2_49 UNDIVIDED FACILITIES – TEMPLATE DISTINCTIONS

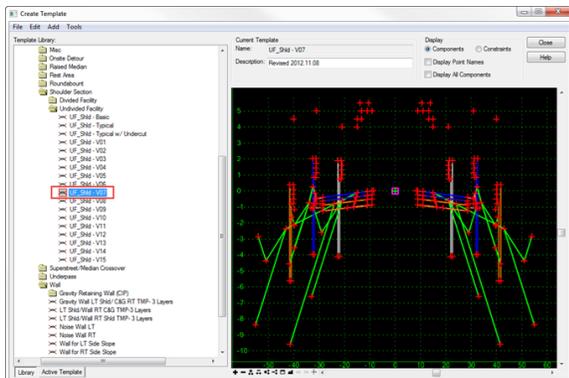
Starting a new project where I am correcting the super on a curve. I have to place two foot paved shoulders as well. The pavement structure is 3, 3 and 4. Would UF-SHLD-V08 be suitable? Would it incorporate wedging?

The only difference with **UF_Shld – V08** with other templates is the freeway/arterial side slopes (end conditions) rather than the default local design side slope (LDSS).
